## SUMMARY

Applicant	Property Location: 10850 Red Lake Pt.			
James. Bray Accuright Surveys	(southwest corner of Red Lake Pt. and Sloane St., in Lake Nona Ph. 1) (Parcel #07-24-31-4733-00-090; ±1.06 acres, District 1).			
Owner				
Daniel Fitzpatrick	Applicant's Request: The applicant propos-			
Project Planner	es to replat a partially developed residential property as part of a residential addition. The			
Jim Burnett, AICP	property is located in the Lake Nona neighborhood.			
	noigheoffhood.			
	Staff Recommendation: Approval of the  Minor Plat, subject to conditions in this staff			
Updated: January 26, 2015	report.

Subject to the conditions contained herein, the Fitzpatrick Subdivision (replat) is consistent with the requirements for approval of Minor Subdivision Plat applications contained in Section 65 Part 3C of the Land Development Code (LDC):

# 2014 SURVEY

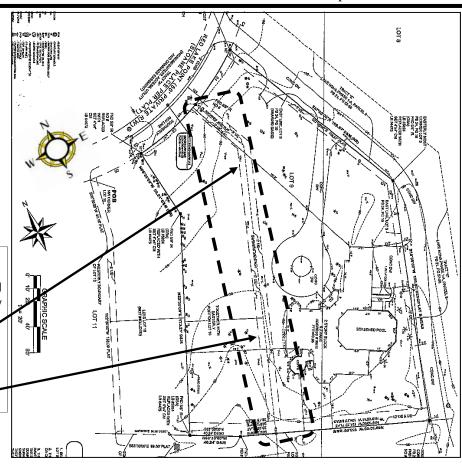
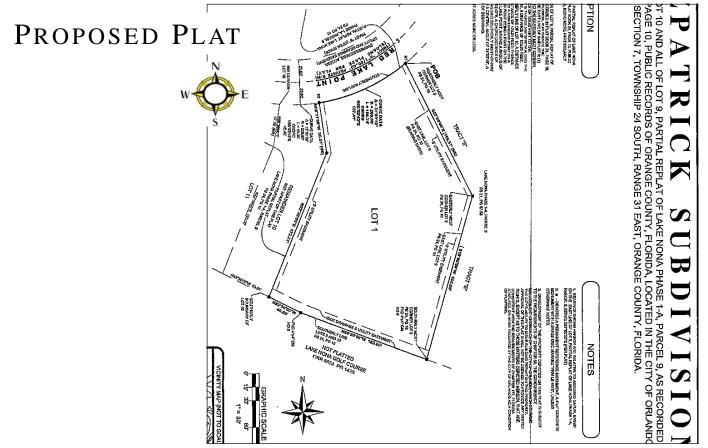
Note location of 5-ft. utility easement along both sides of the lot line separating Lots 9 & 10. When half of Lot 10 was sold to the applicant, both the subject property and the property to the west should have been replatted, to relocate the utility easement to the new shared lot line. A home was subsequently constructed on Lot 11 and the western half of Lot 10 without requiring a replat, *in error*.
